**Village of Mount Prospect
Transportation Safety Commission
Regular Meeting Agenda
1720 W. Central Road Mount Prospect, IL 60056**

August 11, 2025	Emergency Operations Center	7:00 PM
------------------------	------------------------------------	----------------

TO: DIRECTOR OF PUBLIC WORKS
FROM: PROJECT ENGINEER
DATE: July 1, 2025
SUBJECT: FNSP – S. WILLIAM STREET – REVISED DESIGN

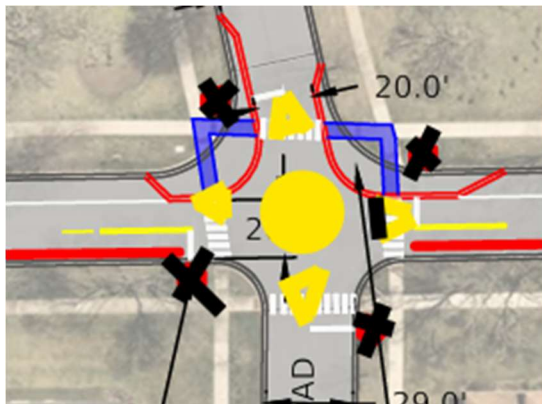
Overall, I am glad with the proposals within the study, and support it. However, I have 2 alternative options I would like to bring forth. I would like to clarify that even if my proposals are infeasible, the study as-is should proceed, as taking any action to fix the traffic would be better than complacency.

While the current proposal for the intersection is an improvement, I believe that a roundabout here would better improve traffic calming. The current proposal already has traces of a roundabout within it, as the two yellow striped sections can act as splitter islands. Below, I have crudely mocked up a drawing in MS paint to demonstrate my idea.

Sunset Road/William Street Intersection

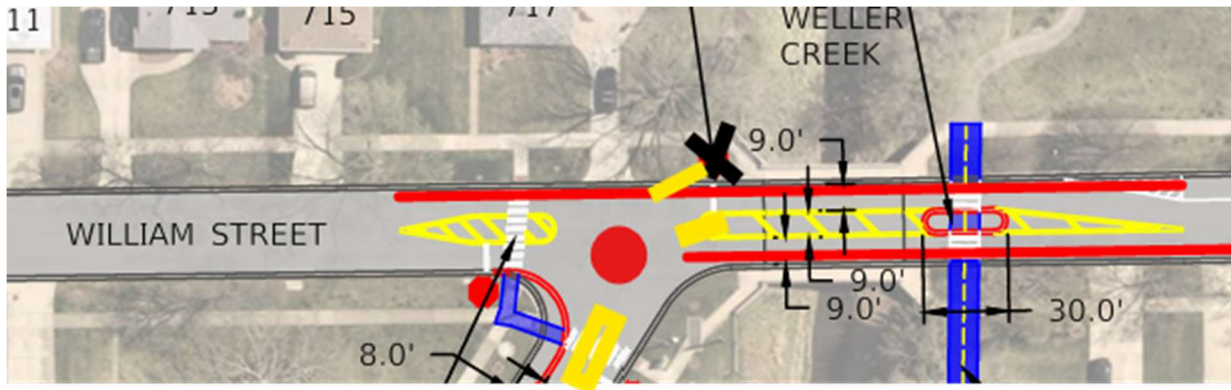
Similarly, I propose a small roundabout here, as there should be ample space for one. Again, I have mocked up a drawing for reference.
